Notice of Intent

HILCORP ENERGY COMPANY
Foothills C 1B
NOTICE OF INTENT TO PERMANENTLY ABANDON

AFMSS 2 Sundry ID 2706614

Well: Foothills C 1B

Foothills C 1B - PROPOSED P&A SCHEMATIC

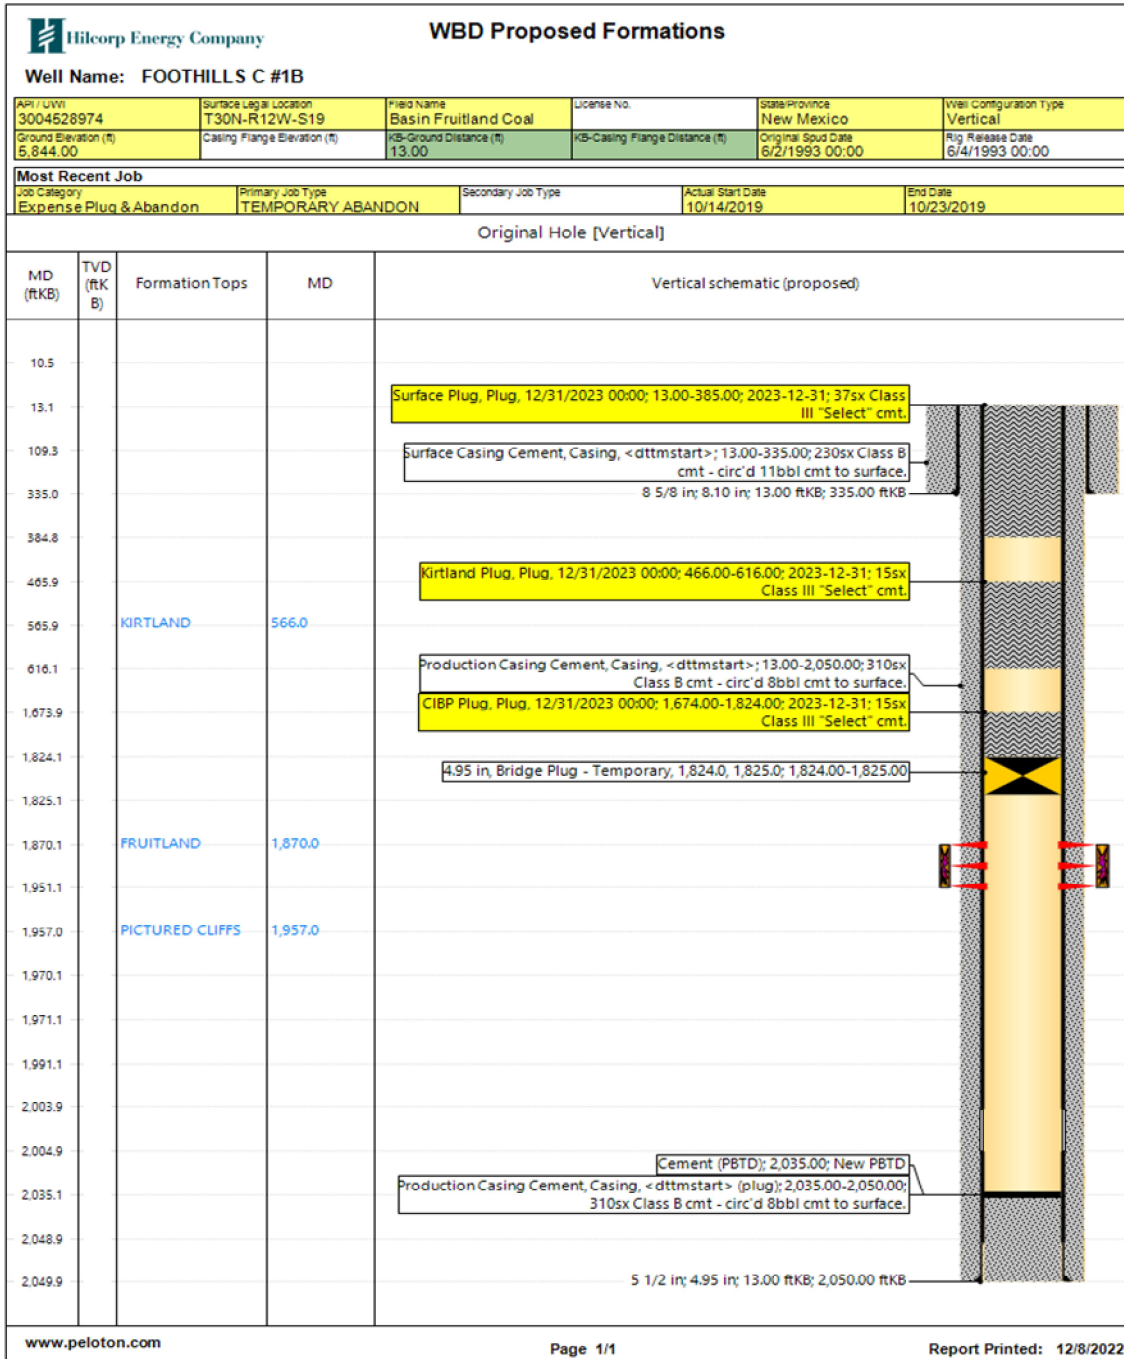
1. Plugging operations authorized are subject to the attached "General Requirements for Permanent Abandonment of Wells on Federal and Indian Lease."
2. The following modifications to your plugging program are to be made:
 - a. Combine Plug #1 and Plug #2 to cover BLM pick for the Ojo Alamo formation top at 408'.
3. Farmington Office is to be notified at least 24 hours before the plugging operations commence at (505) 564-7750.

- Combine Plug #1 and Plug #2 to cover BLM pick for the Ojo Alamo formation top at 408'.

You are also required to place cement excesses per 4.2 and 4.4 of the attached General Requirements.
